**Date** April 3, 2024 Report No. 2024-201

Committee of Adjustment Decision Regarding Applications for Consent and Minor Variance

**APPLICATION NO.:** B15-2024, A15-2024

**LOCATION:** 111-113 Pearl Street

Figure 1 - Proposed Severance and Addition

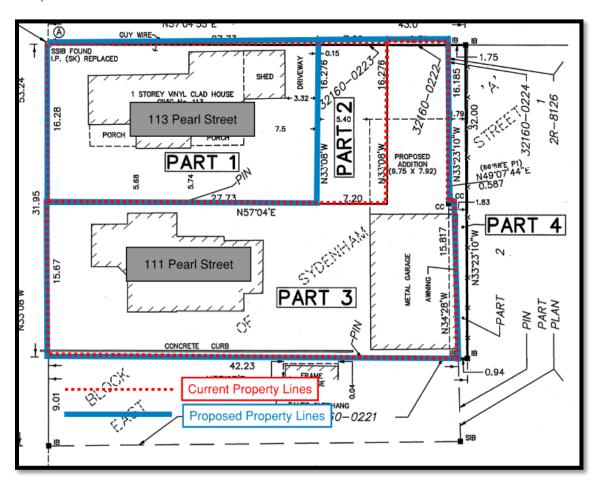
**Development Engineering Department** staff cannot support a 0 m setback to the adjacent property without an agreement between adjacent property owners addressing stormwater runoff, and ensuring that it would be properly managed and conveyed to the municipal ROW. Staff are furthermore concerned with the maintenance of the hard cap concrete surface on the City owned lands. The 0 m setback does not allow for this conveyance to be achieved as well as prohibits required maintenance and ultimate life cycle replacement of the hard cap surface on the neighboring property.

**Building Department**\_staff note that if approved, the addition to the accessory building at the rear of 111 Pearl Street will not be permitted any openings, in accordance with the Ontario Building Code. Building Department staff also note that this building face must have a fire-resistance rating of not less than 45 minutes, using clad and noncombustible materials.

Four Tests	Discussion
1. That the requested variance is <b>minor</b> in nature	"Minor" is determined by impact, not by the value of the variance being sought. While the proposed 3.32 m rear yard setback for 113 Pearl Street may be considered minor, the proposed 0 m setback to facilitate the addition to the accessory structure on 111 Pearl Street is not considered minor in nature since the absence of a rear yard setback on this site may impede proper stormwater management and maintenance of a remediation site on the rear abutting property. This could pose significant risks to both the subject property and adjacent parcels. The proposed elimination of a rear yard and accessory lot

4. That the variance is desirable for the appropriate development and use of the land, building or structure	Considering the factors listed above, it is evident that the proposed minor variance for the 0 m setback on 111 Pearl Street is not desirable for the site. Granting such a variance could exacerbate existing drainage concerns onto neighbouring properties, potentially compromising environmental integrity and community well-being. The variance request for a 3.32 m setback on 113 Pearl Street only serves to facilitate the extension of the accessory structure, and so this variance is also considered undesirable for the appropriate use of the subject lands.

A. THAT application A15-2024 seeking relief from Sections 6.3.1.1 and 6.3.1.3.3 of Zoning By-law 160-90 to permit an accessory lot coverage of 20.1%, whereas a maximum of 18.7% is otherwise permitted, and to permit the extension of a 0 m rear yard setback, whereas 7.5 m is otherwise required, on the lands municipally known as 111 Pearl Street, BE REFUSED;

- C. THAT application A15-2024 seeking relief from Section 7.8.2.1.6 of Zoning By-law 160-90 to permit a rear yard setback of 3.32 m whereas 7.5 m is otherwise required, on the lands municipally known as 113 Pearl Street, BE REFUSED;

- E. THAT Consent application B15-2024 requesting to transfer a parcel of land that is approximately 117.18 m² from the subject property at 113 Pearl Street to the subject property at 111 Pearl Street, BE REFUSED;
